SERVICE BULLETIN

292 73 2088

ARRIEL 2 B1 - B1A - C2 - C2-CG

Subject: Adjusted hydro-mechanical unit (HMU). Reduced torque of the metering valve emergency control.

ANNEXE 1 / APPENDIX 1

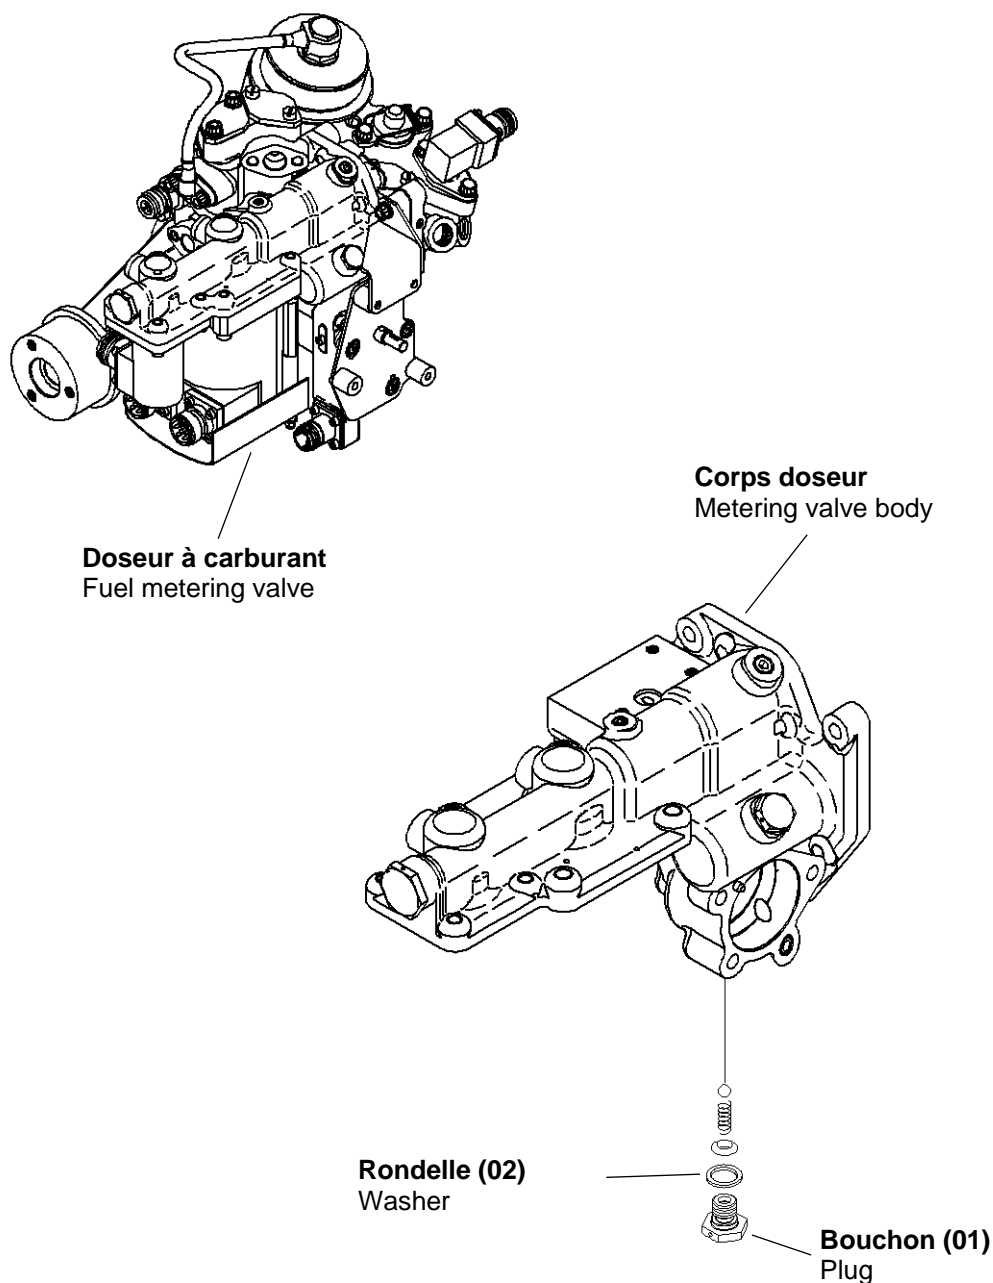
The purpose of this modification is to reduce the maximum torque for transitioning out of the neutral notch and the continuous friction torque in manual mode.

Torque reduction is achieved by adding a washer.

(b) Remove plug (01) from fuel metering valve: refer to the applicable ARRIEL 2 Component Maintenance Manual.

(d) Install plug (01) equipped with new washer (02) on fuel metering valve: refer to the applicable ARRIEL 2 Component Maintenance Manual.
